July 4, 1996

Subject: Clinton Power Station Response to Request for Additional
Information Related to Proposed Amendment of Facility
Operating License No. NPF-62 (LS-94-004)

Questions and Responses

Figure 1

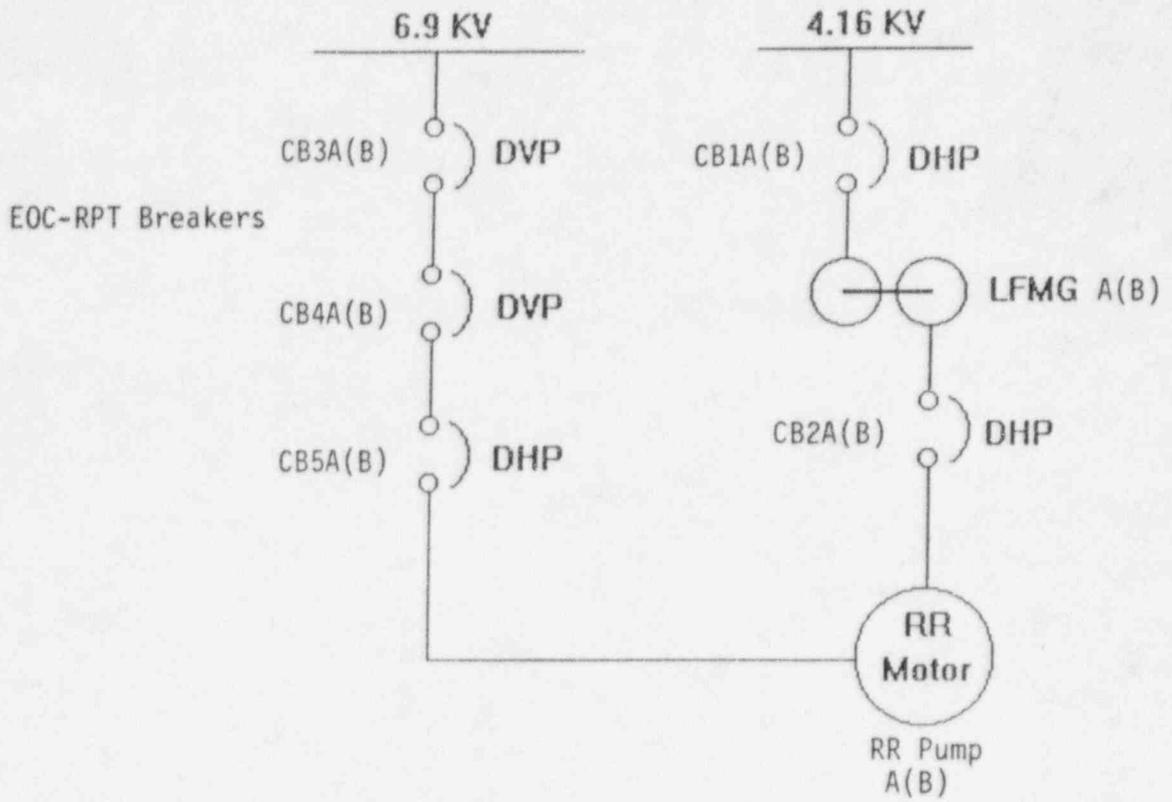
A failure which seldom occurs will, in fact, occur. Since the failure mode determination has apparently been done by Illinois Power Co. (IP), the staff would like to review the failure modes. In addition, the staff would like a more definitive, preferably numerical probability of failure to open within specified time limits without failure to operate than 'seldom' or 'most likely'."

It should again be noted that due to redundancy in the EOC-RPT design (see Figure 1), failure of one DVP breaker would not result in a loss of tripping function. Based on redundant design, proper conservative maintenance and CPS history failure, reasonable assurance exists that the EOC-RPT breakers will perform their intended design function over the lifetime of the plant (without requiring periodic performance of a test to determine the breaker interruption time).
